UNITED STATES PATENT AND TRADEMARK OFFICE

10/509,994

Office Action Summary	Application No. 10/509,994	Applicant(s) CHENE ET AL.	
	Examiner Nahid Amiri	Art Unit 3679

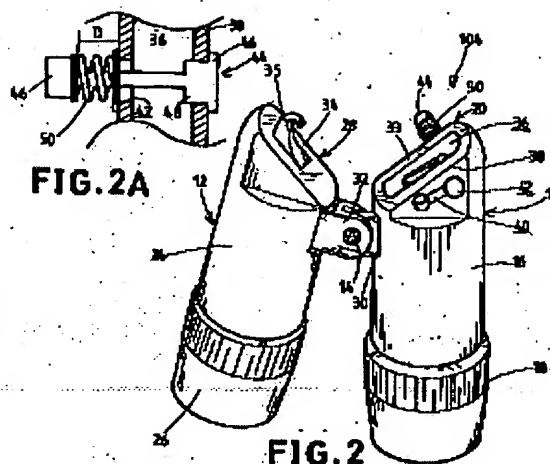
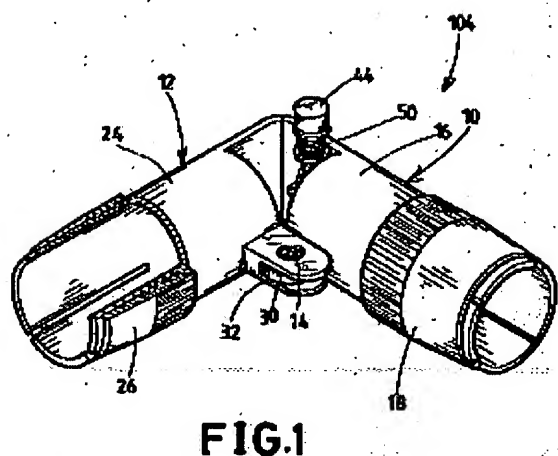
With respect to claim 16, Liao discloses a system of articulation (**Figs. 1-2A**) comprising at least one pivot point between one end (33) of a first rigid element (10) and one end (34) of a second rigid element (12), said ends (33, 34) having bearing faces fit for pairing up respectively one on top of the other, elastic means (50) being provided to maintain the bearing contact between said faces, wherein said system comprises two pivot parts (**constituted by a recess 36 of first rigid element 10 and a hook 25 of second rigid element 12**), each having a recessed zone limited by an at least partially curved surface, each of said pivot parts (36, 35) depending respectively on one of said rigid elements (10, 12), said pivot parts (10, 12) being substantially orthogonal to each other, and engaged one in the other through interlocking of their respective recessed zone, such as to be able to pivot relative to each other in the manner of the links of a chain, with the result that said system comprises two intangible pivot points (**constituted by contact points between two rigid elements 10 and 12**) movable in the two orthogonal planes of said pivot parts (10, 12) within the limits permitted it by said recessed zones, and said system additionally comprising means (**constituted by inclined portions of the ends of the two members 10 and 12**) which allow pivoting only in one or some planes, the number and orientation of which are defined.

With respect to claims 17, 21 and 26, Liao discloses (Fig. 1) that the pivot parts (10, 12) take the form a hook (35) having a recess (36) limited by an at least partially curved surface; wherein an anti-rotation relief (constituted by a device made of lugs 30, 32 and pin 14) is provided on one of the pivot parts (10, 12); and wherein the rigid elements (10, 12) are respectively a spectacle side-piece and a spectacle face.
